FINAL DRAINAGE REPORT FOR CLAREMONT BUSINESS PARK 2 FILING NO.1

EL PASO COUNTY, COLORADO

AUGUST 2020

Project #44-037
PCD – SF- 20-014

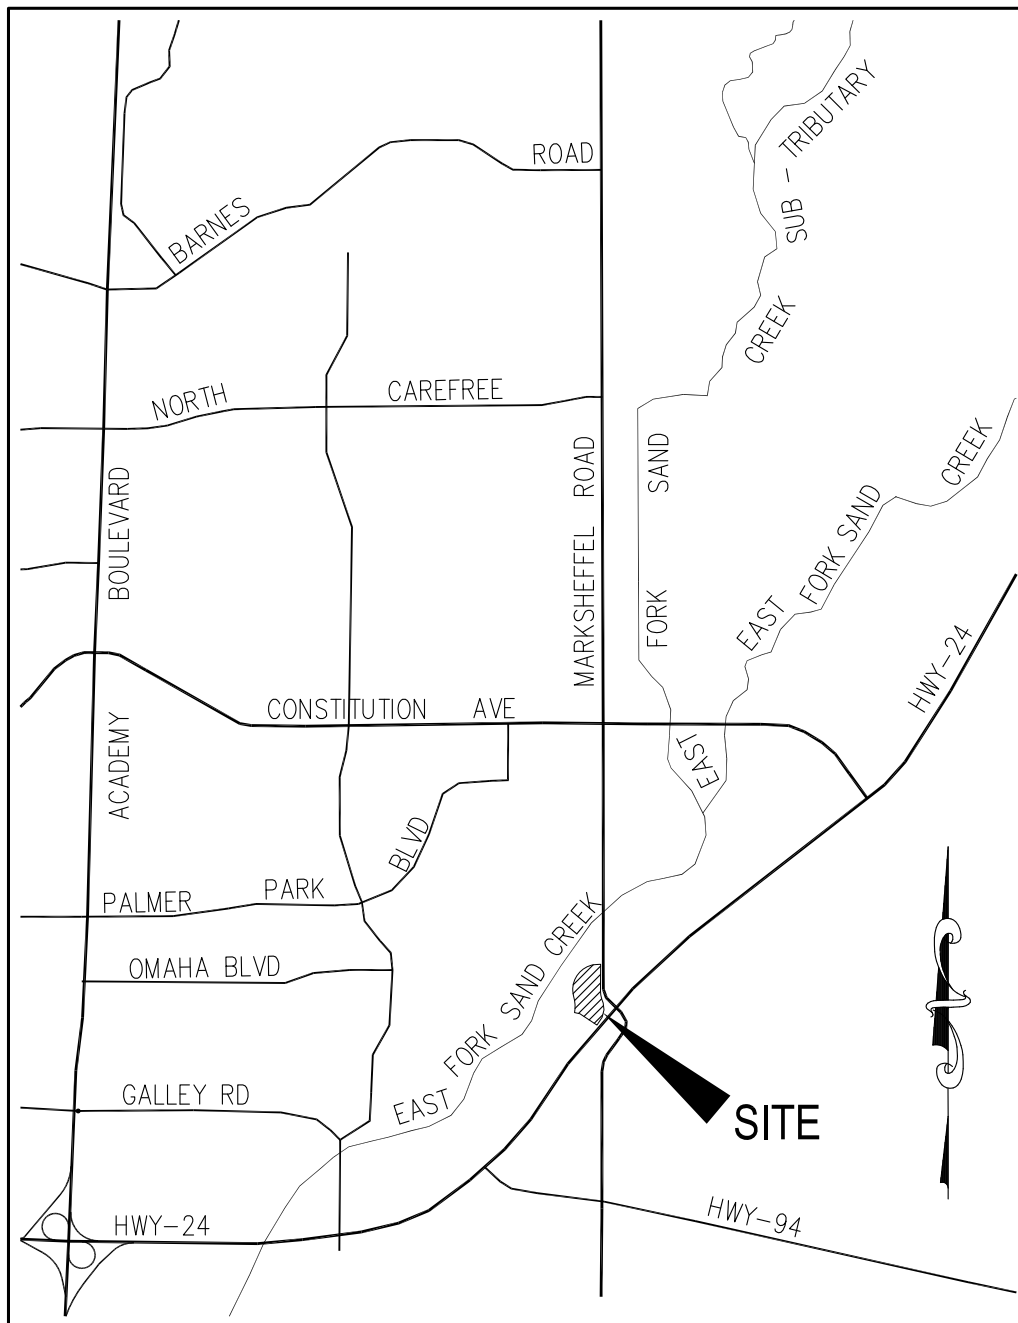
It appears that this may be the calculated impervious of basins B1 & B2. Please **also** state that the previously paid fees were based on 80% impervious as shown in the excerpt attached to your report and to match what is indicated in the letter of intent.

INLET ON A CONTINUOUS GRADE

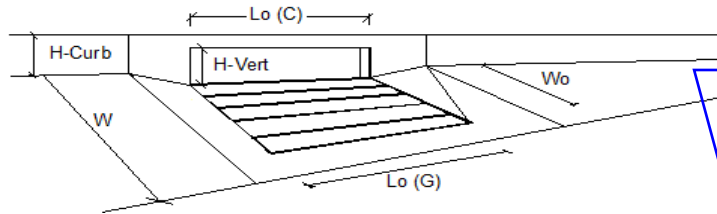
Review #1: Revise so that it matches the CD's and drainage plan. Inlet 1 is indicated as 15' on the CD's.

INLET ON A CONTINUOUS GRADE

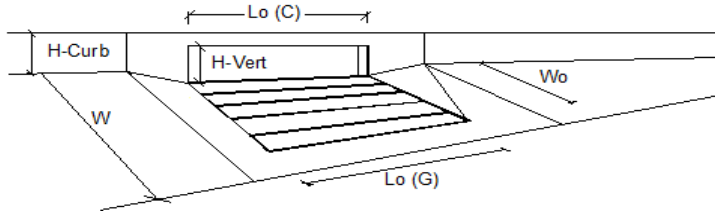
Review 1 comment: Revise so that it matches the CD's and drainage plan. Inlet 2 is indicated as 10' on the CD's.
Review 2: Unresolved. Revise to match the CD's and drainage plan which now indicate a 15' inlet.

| INLET ON A CONTINUOUS GRADE | | | | | | | | | | | | | | | | | | | | | | | | | | | | | | | | | | | |

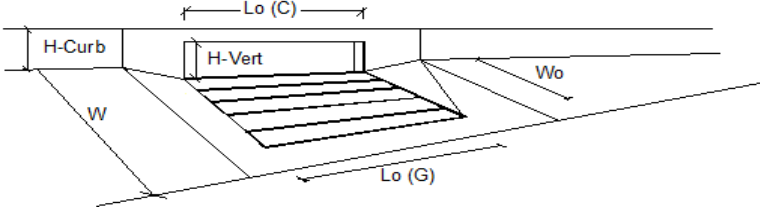
Review 1: Revise so that it matches the CD's and drainage plan. Inlet 3 is indicated as 15' on the CD's.
Review 2: Unresolved.

INLET ON A CONTINUOUS GRADE

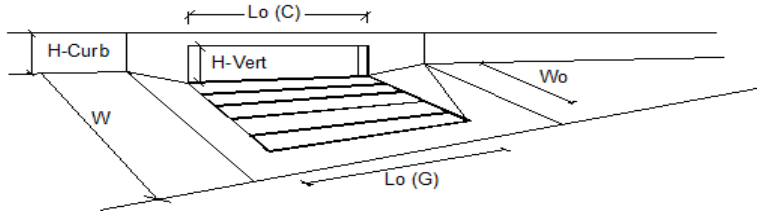
Review 1: Revise so that it matches the CD's and drainage plan. Inlet 4 is indicated as 10' on the CD's.
Review 2: Unresolved. Please revise to match the CD's and drainage plan which now indicate a 15' inlet.

STORM 6, 7 INDEX MAP

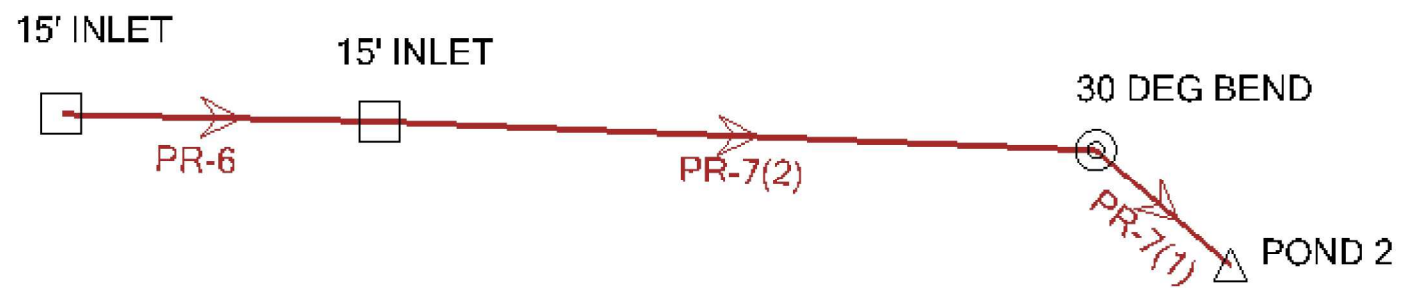
Review 1: The flow is greater than the capacity. Revise accordingly.
Review 2: Unresolved
